Project	IEEE 802.16 Broadband Wireless Access Working Group < http://ieee802.org/16 >	
Title	Clarification on UL CQICH SNR feedback for MIMO systems	
Date Submitted	2005-04-28	
Source(s)	Jianzhong (Charlie) Zhang, Anthony Reid, Kiran Kuchi, Heikki Berg, Nico Van Waes Nokia Research Center 6000 Connection Drive Irving, TX 75039	Voice: 972-374-0958 Fax: 972-894-5937 charlie.zhang@nokia.com
Re:	IEEE 802.16e D5 Draft	
Abstract	Proposes an improved channel quality indicator for vertically encoded MIMO systems	
Purpose	To incorporate the changes proposed here into the 802.16e D6 Draft.	
Notice	This document has been prepared to assist IEEE 802.16. It is offered as a basis for discussion and is not binding on the contributing individual(s) or organization(s). The material in this document is subject to change in form and content after further study. The contributor(s) reserve(s) the right to add, amend or withdraw material contained herein.

Clarification on UL CQICH SNR Feedback for MIMO Systems

Figure 229b – Post Processing S/N for MIMO

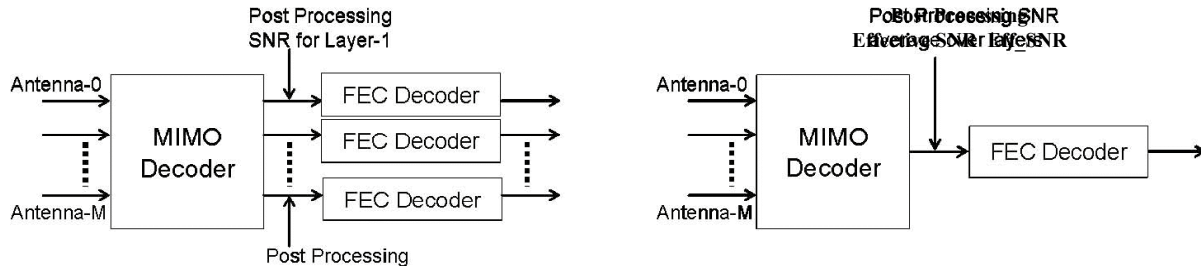
MIMO capable MS shall measure post processing S/N for each individual layers as shown in Figure 229b. When the FAST_FEEDBACK subheader Feedback Type field is "00", the MS shall report the post processing Effective SNR (Eff_SNR) as defined below. When BS requests MS feedback through CQICH_Alloc_IE() or CQICH_Enhanced_Alloc_IE() with '00' Feedback_type field, MS shall report Eff_SNR or individual layer S/N as described in 8.4.5.4.12 and 8.4.5.4.15
